City of Los Altos

Objective Design Standards

City Council Adoption Hearing (continued) | August 24, 2021

Key Revisions/ Discussion Topics

Relative Ground Floor Floor-to-Ceiling Height

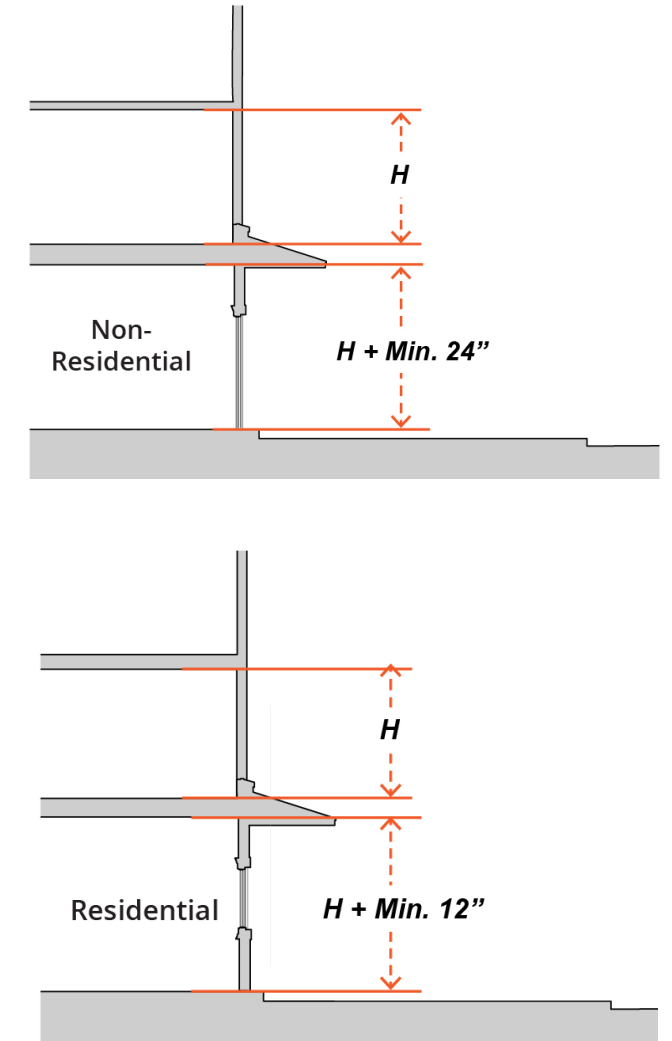
Zones	Standards	
CN	14.40.150.C.3	
CD	14.44.130.B.4	
CRS	14.48.130.B.4	
CT	14.50.170.C.4	Minimum 24 inches taller than typical upper floor floor-to-ceiling height where ground floor is non-residential.
CD/R3	14.52.110.B.3	
CRS/OAD	14.54.130.B.4	Minimum 12 inches taller than typical upper floor floor-to-ceiling where ground floor is residential.
R3-4.5	14.16.100.B.4	
R3-5	14.18.120.B.4	
R3-3	14.20.120.B.A	
R3-1.8	14.22.110.B.4	
R3-1	14.24.110.C.7

Upper-story Step-backs

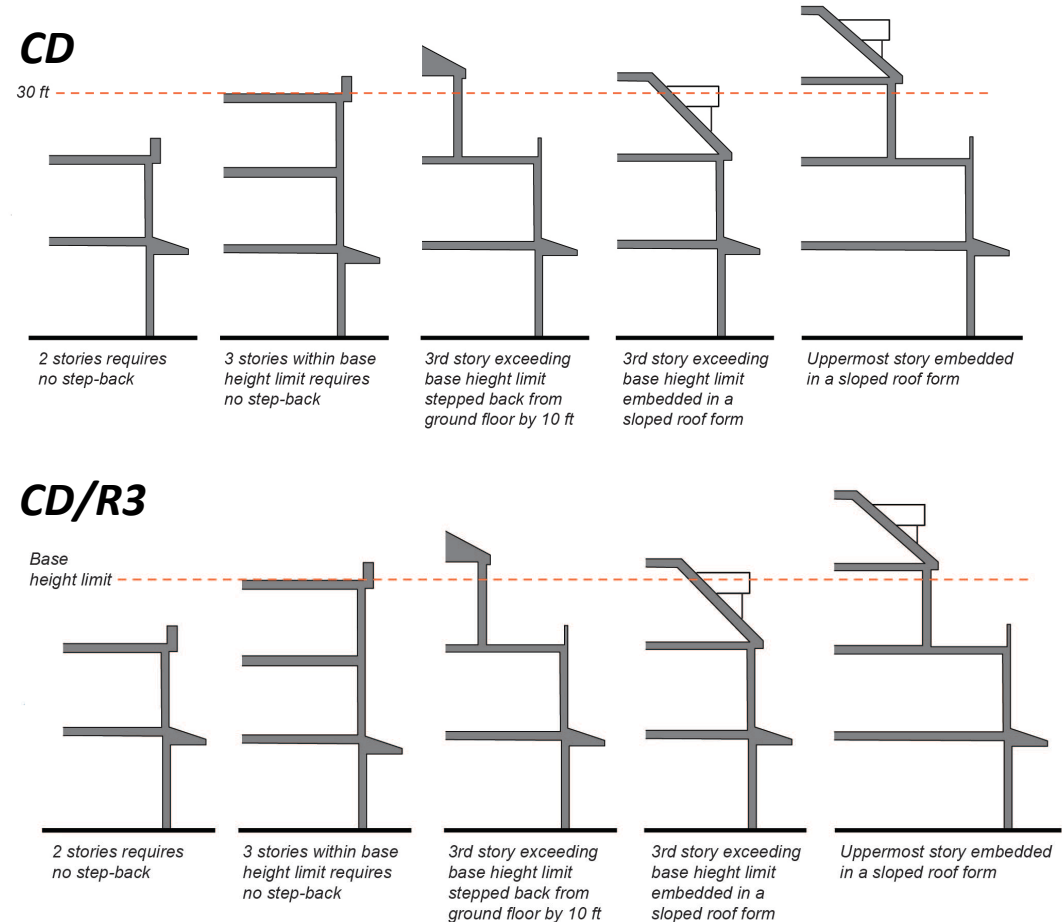
Zones	Standards
CD	<p>14.44.130.A.1</p> <ul style="list-style-type: none"> • Front and street side above the base height limit (30 ft) must be stepped back 10 ft • 4th story and above, top story must be embedded in a sloped roof
CD/R3	<p>14.52.110.A.1</p> <ul style="list-style-type: none"> • Front and street side above the base height limit (30 ft for commercial or mixed-use and 35 ft for residential-only) must be stepped back 10 ft • 4th story and above, top story must be embedded in a sloped roof • Updated diagram dotted line to say “base height limit.”

- Per direction, 10-ft step-back is required beyond base height limit.
- When a 3rd story exceeds the base height limit, it must be stepped-back OR embedded in a sloped roof form.
- If a stepped-back uppermost story is included in a sloping roof form, the floor below must be stepped back as well.

Upper-story Step-backs

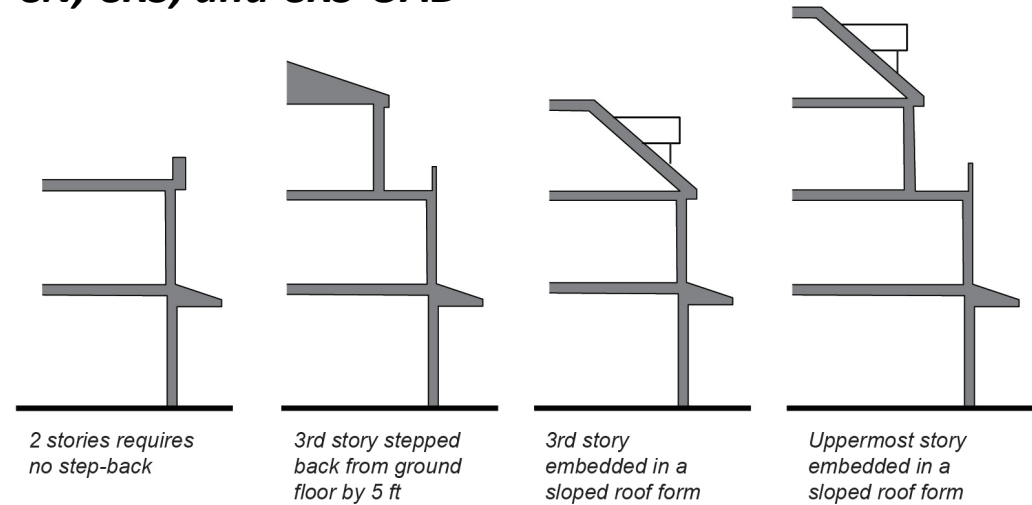
Zones	Standards	
CN	14.40.150.B.1	<ul style="list-style-type: none"> 3rd story stepped back 5 ft <u>or</u> embedded in a sloped roof form (applies all street-facing frontages except those along El Camino Real) 4th story and above, top story must be embedded in a sloped roof (does not apply to ECR)
CRS	14.48.130.A.1	<ul style="list-style-type: none"> 3rd story stepped back 5 ft <u>or</u> embedded in a sloped roof form
CRS/OAD	14.54.130.A.1	<ul style="list-style-type: none"> 4th story and above, top story must be embedded in a sloped roof
CT	14.50.170.B.1	Min. 10-ft step-back above base height limit (45 ft)

- 5-ft step-back is required for all 3rd stories, regardless of building height.
- If a stepped-back uppermost story is included in a sloping roof form, the floor below must be stepped back as well.

Architectural Integrity/Materials Palette

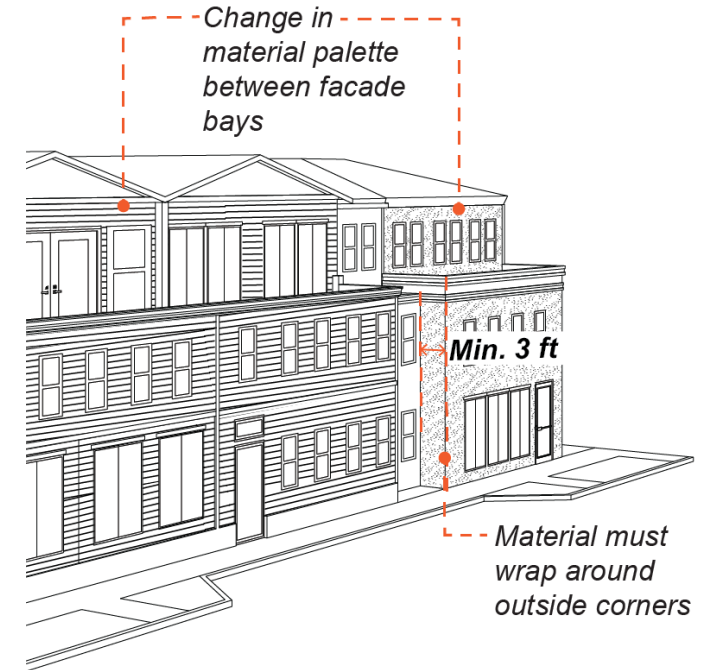
Zones	Standards	
All Zones	14.66.280.A.1	<p>Replaced the “Architectural Integrity” standards with the following:</p> <ul style="list-style-type: none"> Material palette on all floors above the ground floor, not including floors contained within a sloped roof form, must be consistent. Change in material may occur only at the inside corner of a change in wall plane. Material must wrap around outside corners
CD	14.44.130.B.1.b.iii	<p>“Change in architectural style” has been edited to “change in material palette.”</p>
CRS	14.48.130.B.1.b.iii	
CD/R3	14.52.110.B.1.b.iii	
CRS/OAD	14.54.130.B.1.b.iii	
R3-1	14.24.110.C.1.b.iii
